## APPENDIX 1

MINUTES OF MEETINGS WITH THE APPLICANT OF 17/07/14 and 12/11/15

This note reviews the evidence presented in Chapter 11 of the Environmental Statement presented by Hills Quarry Products in support of their planning application to open a new sand and gravel quarry, called “Fullamoor Quarry”, in the parish of Clifton Hampden.

# Landscape and Visual Report to Review the LVIA Supporting the Planning Application for a New Quarry at Fullamoor Farm

VP3 - View from A415 near to South Cottage.

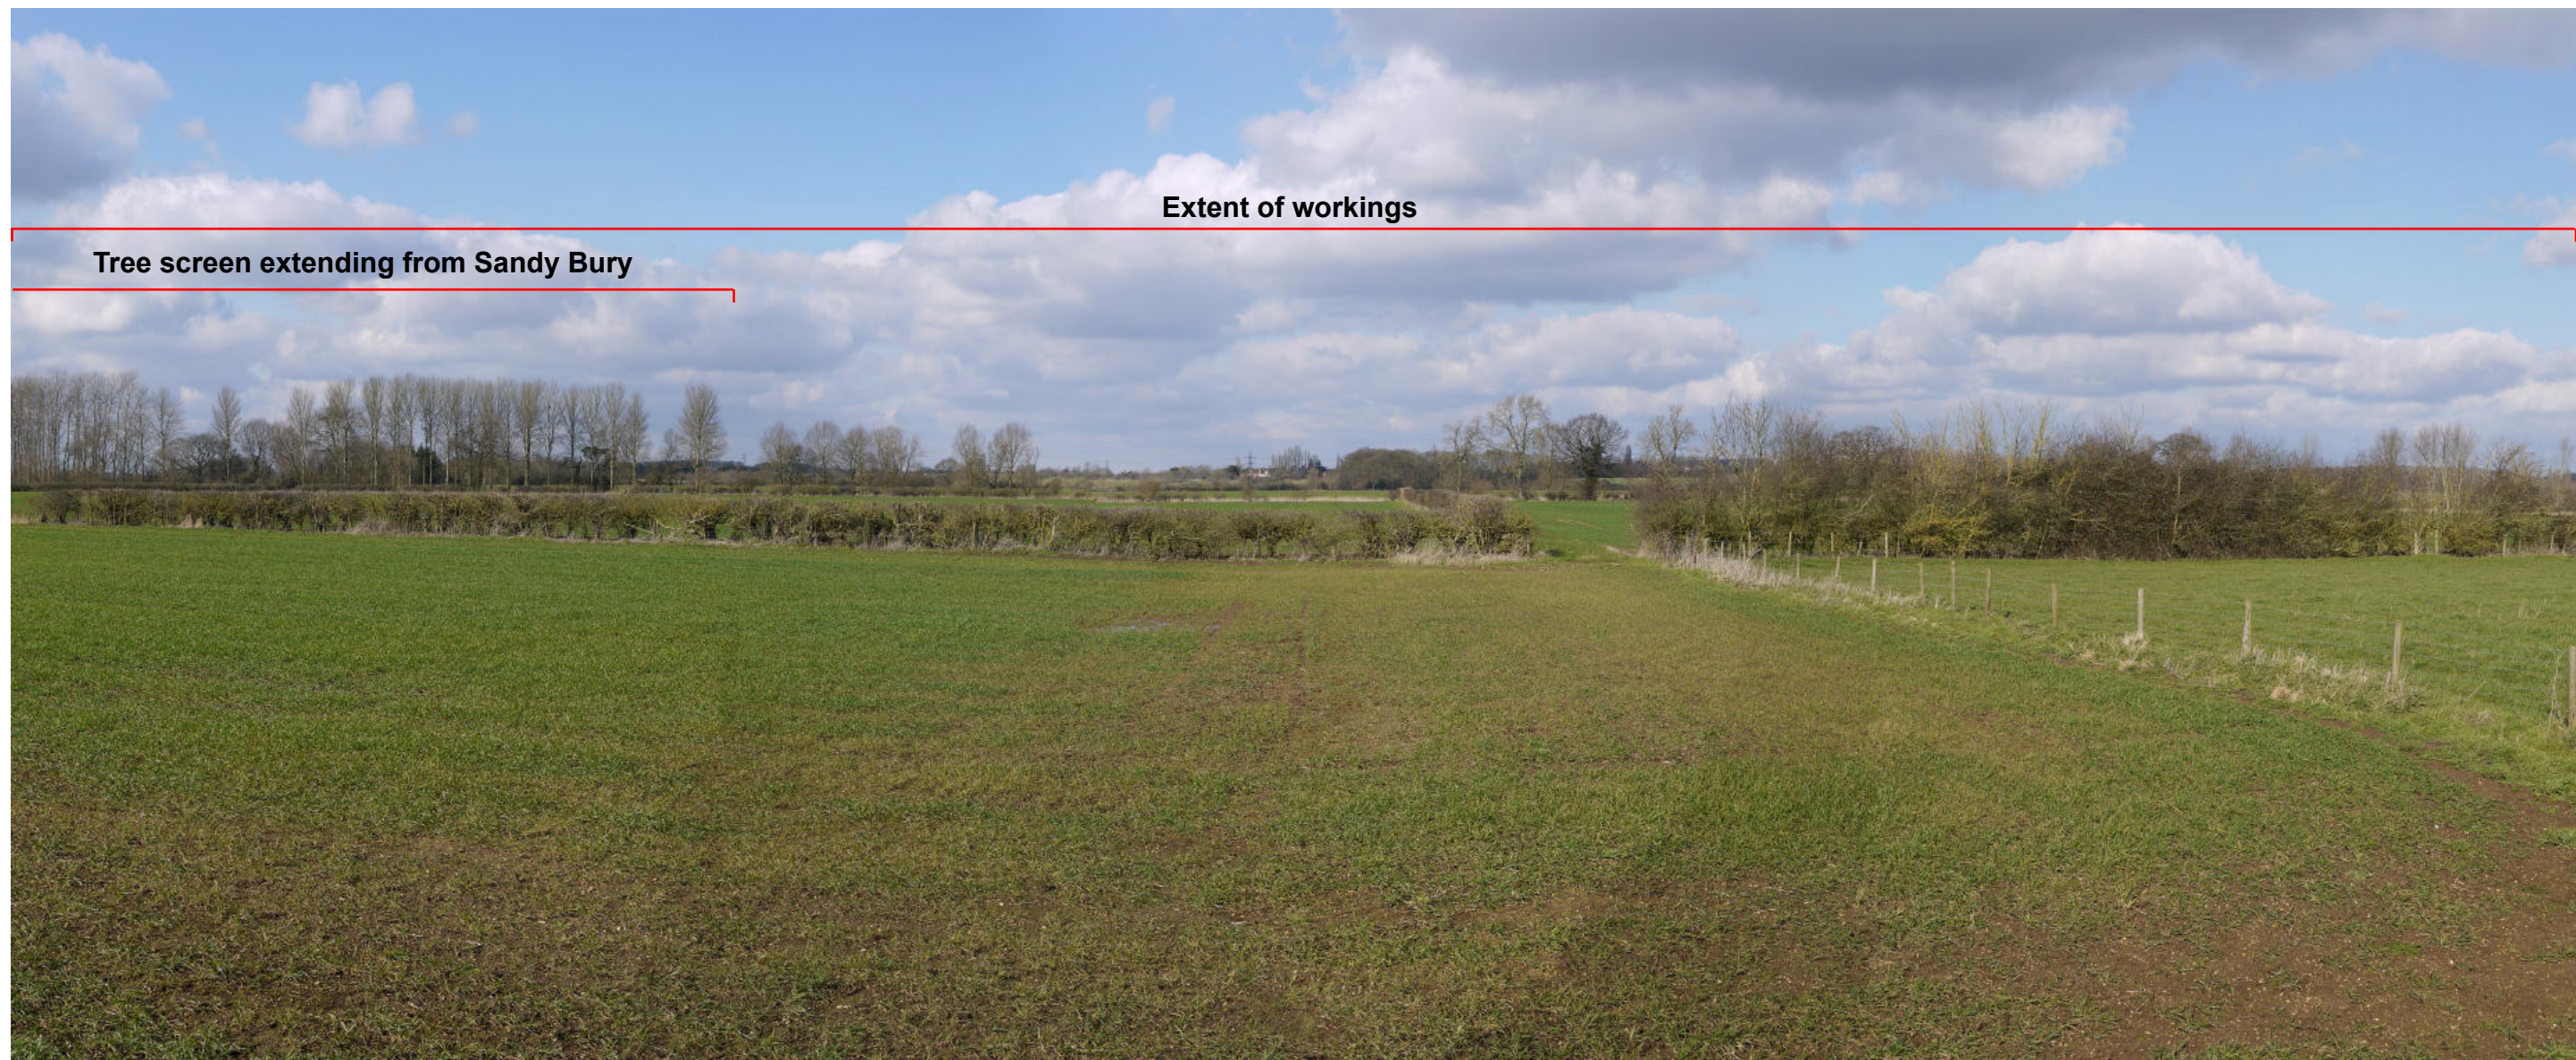
- 3.42 This assessment concludes that the impact during the operational life of the quarry will be Minor Adverse. This does not seem to take into account the change to the setting of the property in terms of the significant loss of the mature trees of Sandy Bury and the other hedgerows in the view. These are unlikely to be replaced to the same degree maturity in the lifetime of the current property owners. Also the introduction of a 10m high artificial bund and other lower bunds immediately south of the property as well as unnaturally shaped silt ponds would be totally uncharacteristic elements within the setting as will be the views towards the workings. I query the conclusion that the impact would be restricted to a Minor level. I would question what level of impact there would need to be to result in a moderate or major impact if the proposed extensive bunding dominating the view does not represent such an effect.
